# Office Action Summary

10/579,704

SPRATT, FRANK

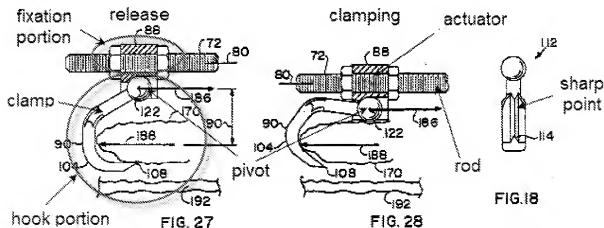
Miskew discloses a hook for fixing a spinal support rod to a vertebra by engaging the vertebra (see figs 18, 27 and 28 below). The hook portion (see fig 27 below) has a recess in which vertebral tissue is received and a fixation portion (see fig 27 below)

which includes a channel in which a spinal support rod is received. The hook includes a clamp having a sharp tip (fig 18, 114) that penetrates the surface of the vertebra. The clamp is pivotally fixed to the hook between a clamping position (fig 28) in which it engages the surface of the vertebra to inhibit removal of the vertebra from within the recess, and a release position (fig 27) in which vertebral tissue can be inserted into and removed from the recess. The distance between the clamping position and the release position is less than 5 mm (the distance between a clamping position and the release position can be very small because the difference from be clamped a not clamped is infinitesimal i.e. very small movement is required to finally lock the system). In the clamping position the recess is smaller (fig 28 compared to fig 27). An actuator that is a grub screw (located on the surface of the rod) causes clamping (col. 9, ll. 39-51). The clamp abuts a stop when clamped (see fig 28 below). The rod directly causes the clamp to penetrate bone. The clamp is inclined (fig 27).
